PROPOSED TECHNICAL SPECIFICATIONS

REGARDING FULL ARC TURBINE CONTROL

NEW YORK POWER AUTHORITY

JAMES A. FITZPATRICK NUCLEAR POWER PLANT

Figure 3.1-2

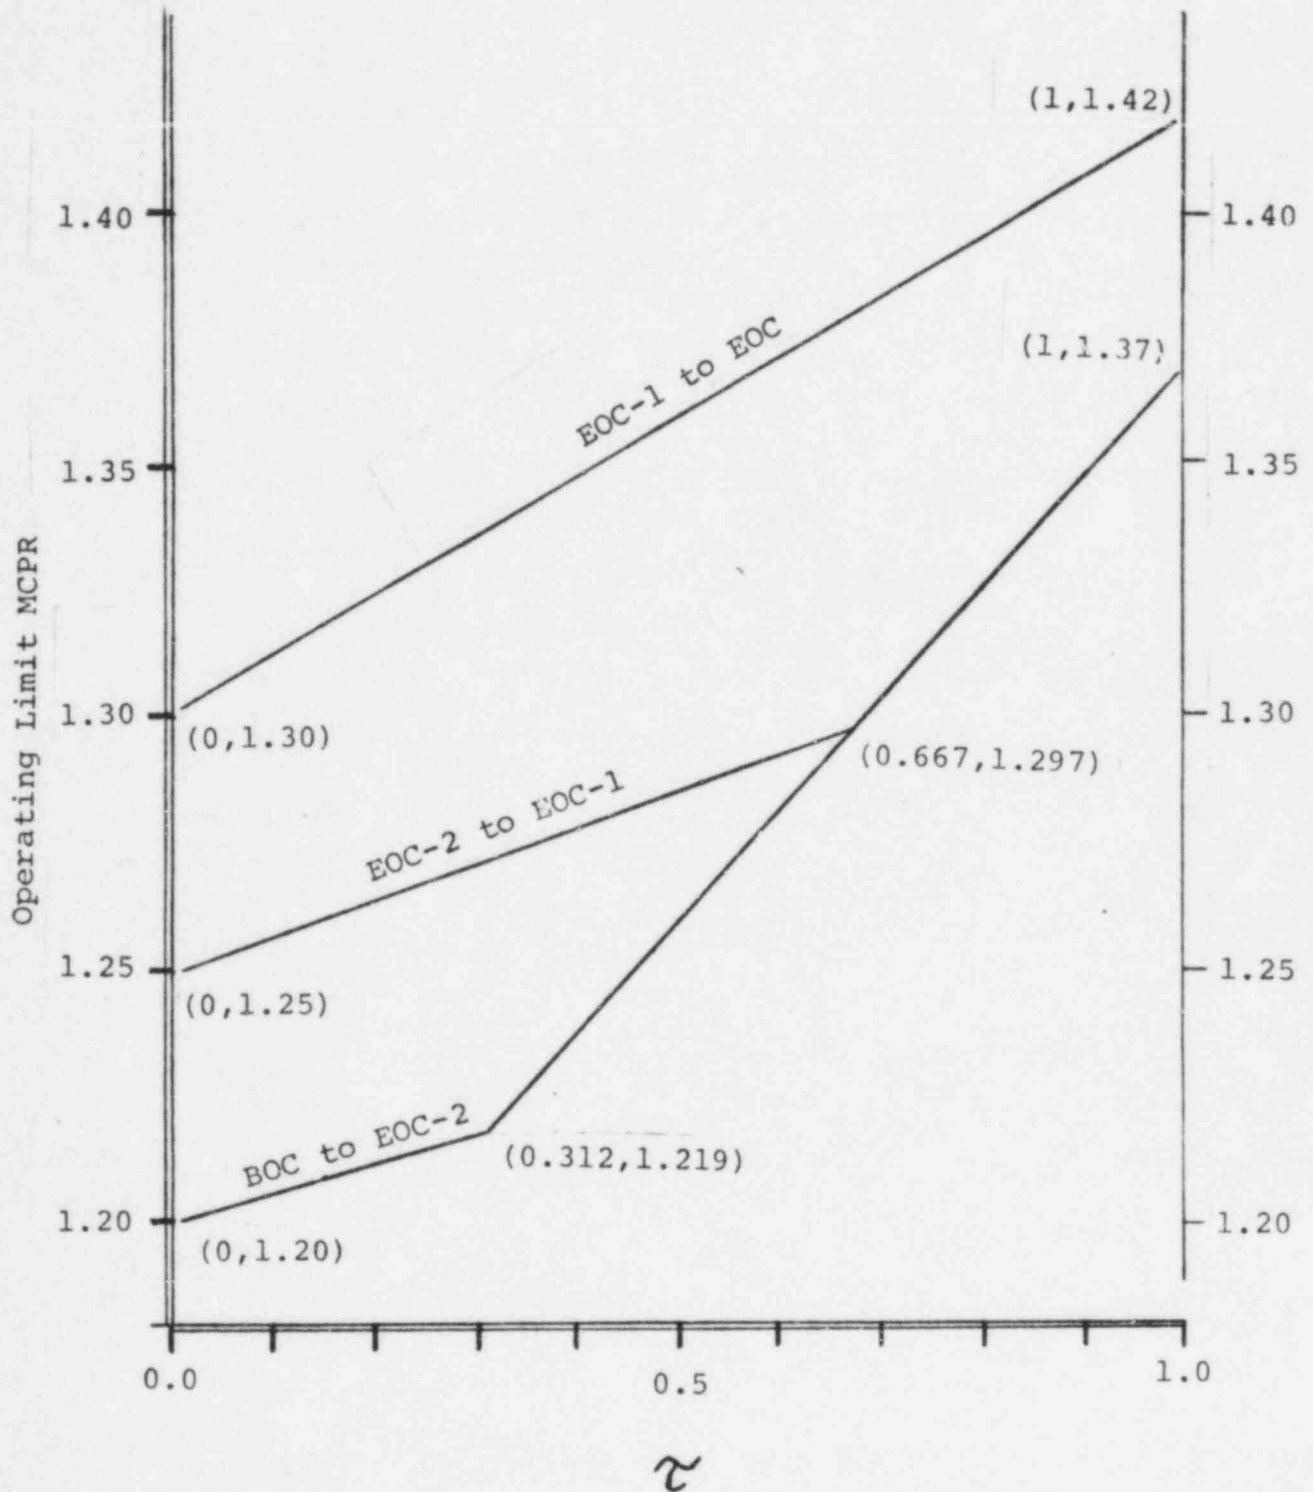
Figure 3.1-2 on page 47b "Operating Limit MCPR Versus γ (defined in Section 3.1.B.2)— For All Fuel Types" has been revised to account for the turbine control valve modification.

The changes proposed for Figure 3.1.2 (page 47b) are necessary only if observed scram times require that MCPR values be corrected (i.e. if ODYN option B is not applicable).
